**PLANNING COMMISSION MEETING  
MUNICIPAL CENTER COUNCIL CHAMBERS  
Tuesday, September 6, 2016**

**4. Request Preliminary and Final Plat Approval of Allelon Subdivision**

Development Case Number	16-638
Case Name:	Allelon Subdivision
Location:	2411 McVay Road
Owner Name:	Lucie May Thompson
Applicant Name:	Boyle Investment Co. - Developer
Representative Name:	Blair Parker w/Blair Parker Design, LLC.- Agent/Representative
Zoning District:	R - Low Density Residential
Area:	25.828 Acres
Request:	Preliminary and Final Subdivision Plat Approval of 50 Lots

**VICINITY MAP**

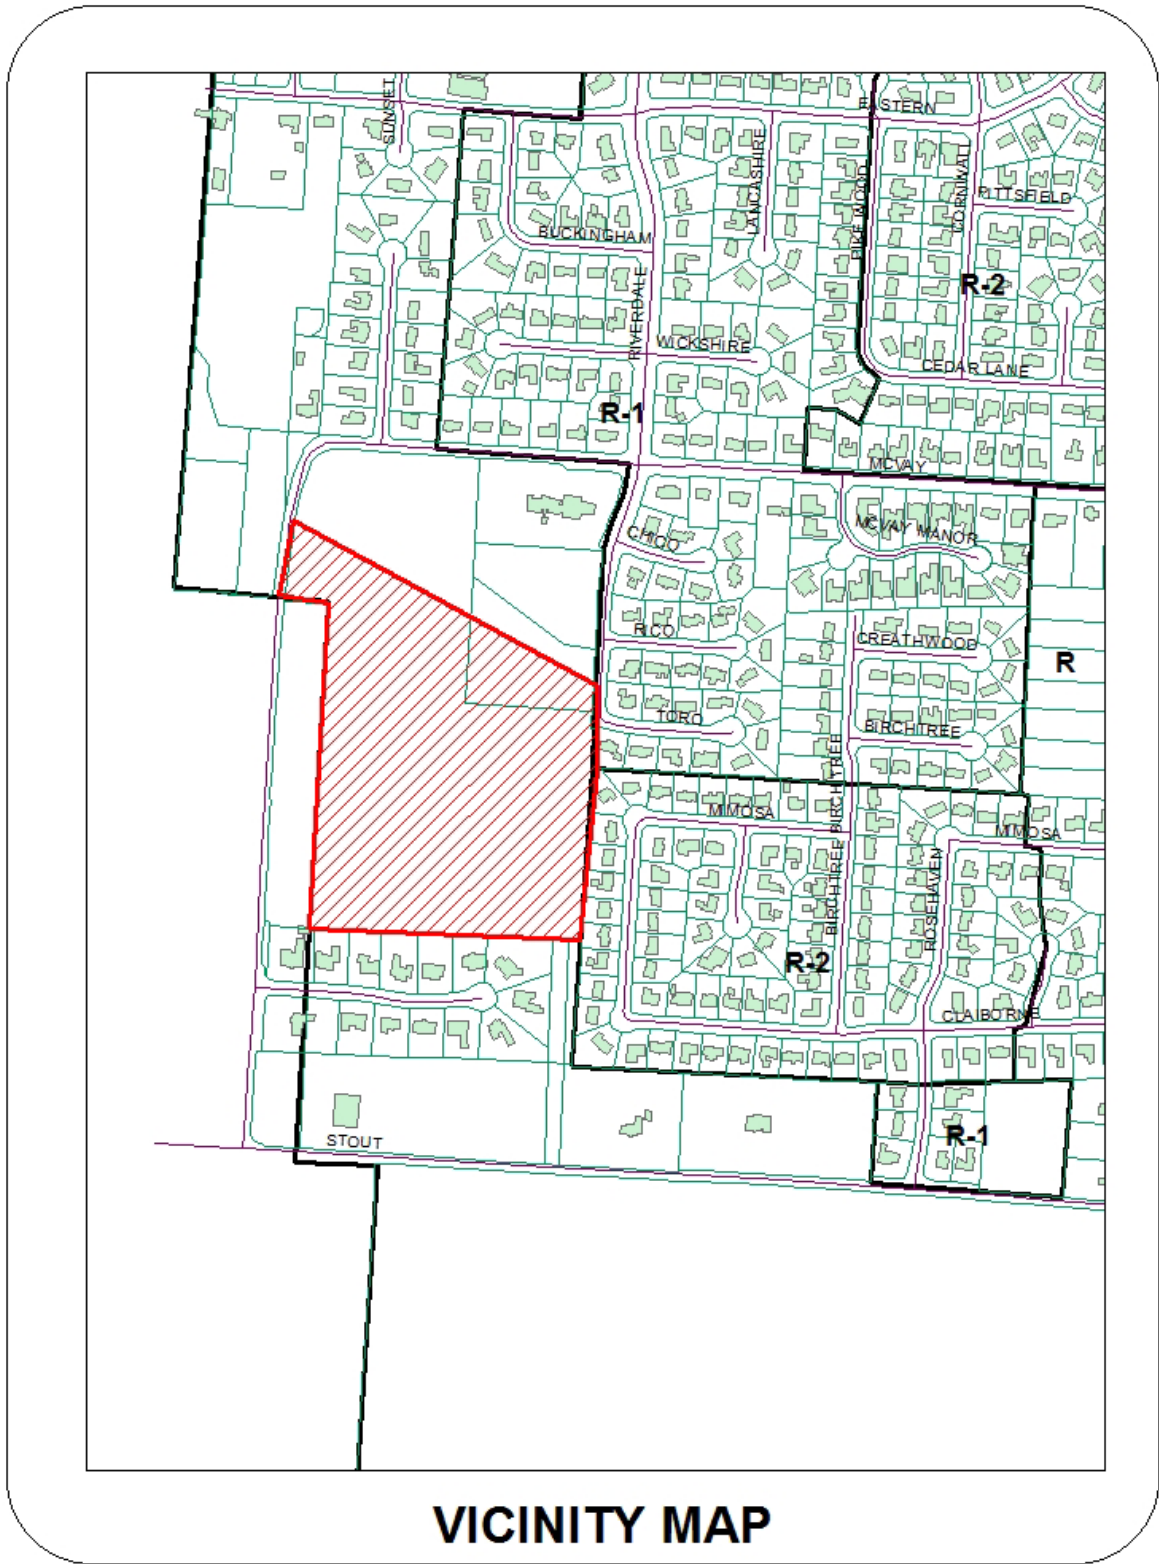
1. Provide a vicinity map that reflects the remainder of the property that this site is being petitioned from to create this subdivision.
2. The typical 5' utility easement needs to be shown along the side and rear property lines and/or a note stating such. The 5' utility easement is a requirement of Section 17-61 of the Subdivision Regulations. If you do not wish to show the easements as required, you must request a waiver in writing from the Planning Commission. This request is to be submitted to the Planning Department with Final Plat submittal.
3. The final plat should show the current zoning of property.
4. Show lot size for Lot 24 on plat.
5. Label Messick and McVay Roads on plat. Label dedication width.

1. Subdivisions require possible parkland dedication or a fee in lieu payment.
2. As Howard Road Creek Outfall is an impaired stream, TDEC's normal requirements is for a 60' construction buffer, however the buffer may be reduced to required permanent 30' width upon approval of same by TDEC and issuance of a NPDES permit with the reduced 30' buffer.
3. Provide erosion control plan. Sites over 10 acres will require sediment basin with wet and dry storage area.
4. Show floodway boundary on final plat.
5. An approved CLOMR will be required prior to construction plan approval.
6. Two water feeds are required for this subdivision. Preferably along McVay to north and can attach to bridge.

7. Add verbiage to plat that COG to maintain stub streets up to new ROW of McVay. Culverts and headwalls under stub streets to be in COG public drainage easements. Also note that positive flow shall be established along McVay side ditch.

8. Provide adequate site distance at entrances to McVay.
9. Use a minimum of 0.75% grade for all subdivision roads.
10. Add curb improvements to the Riverdale/Toro Cove intersection area and address any drainage issues.

11. Do not show drainage swales on property lines.
12. The roadway plan and profile sheets shall indicate top of curb spot elevations for all proposed curb and gutter at all end of radii (ER's), horizontal angle points and at vertical transition locations (break points).

13. Part of this site is within the FLOODWAY according to the FEMA maps. No construction shall be permitted within the floodway. The floodway boundary line shall be graphically shown on the final plat and grading plan.

15. Minimum finished floor elevations shall be indicated on the plat and grading and drainage plan sheets.
16. This project must comply with the Tennessee Department of Environment and Conservation NPDES Regulations governing Stormwater discharge. The construction drawings shall include an erosion control plan, which is in conformance with these regulations, and provide a copy of the Developer's Notice of Intent (N.O.I.) as submitted to the Tennessee Department of Environment and Conservation (TDEC).

17. The areas denoted as "reserved for Stormwater detention" may not be altered without first obtaining the written permission from the City Engineer's. The Stormwater detention system located in this area shall be owned and maintained by the property owner or a homeowner's association. Such maintenance shall be performed to ensure that the system operates in accordance with the approved drainage plans on file in the City Engineer's office. Such maintenance shall include, but not be limited to: Removal of sedimentation, fallen objects, debris, trash, mowing, and outlet cleaning. A statement to this effect shall be noted on the final plat.

Detention basins are to be designed for the 50-year storm with intermediate controls for the 2,5,10 and 25-year storms.

18. Fire hydrant spacing shall be 500 feet between each hydrant with the hydrant being visible from 100 feet away without obstructions.
19. Water supply to the subdivision shall be looped to ensure the needed fire flow and to remove the existing dead end main on McVay.
20. Addresses of the homes shall change street names and numbers at Lots 9 & 46 from Allelon Circle North and Allelon Circle East.
21. Lot 15 shall be the change of address numbers and street names from Allelon Circle East to Allelon Circle South.
22. There shall be a 3 foot circumference clearance around the fire hydrants.

A.2. Revise comment to read “The typical 5’ utility easement needs to be shown along the front, side and rear property lines of all lots or a note stating such, except where the City Engineer may grant a waiver. A waiver to this rule may be granted by the City of Germantown when a plan from Memphis Light Gas and Water (MLG&W) denoting no need for such easement is provided.”

B.9. They would prefer this note to read: “Use a minimum of 0.5% grade for all subdivision roads”, which is the accepted street minimum in this region.

B.10. Request this comment be rewritten to read: “Add curb improvements to the Riverdale/Toro Cove intersection in such a manner to not impede drainage in this intersection.”

B.13. Change the wording from Floodway to Flood Plain in the first sentence. Strike the second line: “~~Part of this site is within the Floodway according to the FEMA maps~~” since no portion of this property is within the Floodway, we ask that this sentence be removed. Change wording to Flood Plain in the last sentence.

Staff agrees as revised to the applicant’s proposed changes to staff comments.
